MIL-R-83536/2
AMENDMENT 2
30 September 1996
SUPERSEDING
AMENDMENT 1
15 December 1995

RELAYS, ELECTROMAGNETIC, ESTABLISHED RELIABILITY, DPDT, LOW LEVEL TO 5 AMPERES, PERMANENT MAGNET DRIVE, HERMETICALLY SEALED, ALL WELDED, TRANSIENT SUPPRESSED DC COILS

This amendment forms a part of MIL-R-83536/2, dated 27 March 1992, and is approved for use by all Departments and Agencies of the Department of Defense.

CIRCUIT DIAGRAM (NO MOUNT, RVFM, HFH AND TRACK MOUNT A)
(OPTIONAL INTERNAL
DIODE CONFIGURATION)

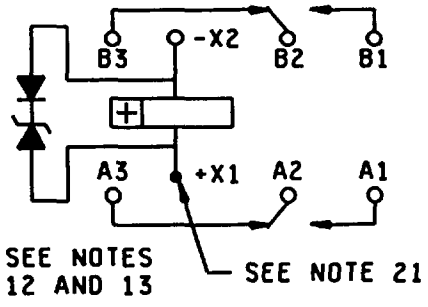
FIGURE 1, add the following circuit diagram between the existing diagrams:
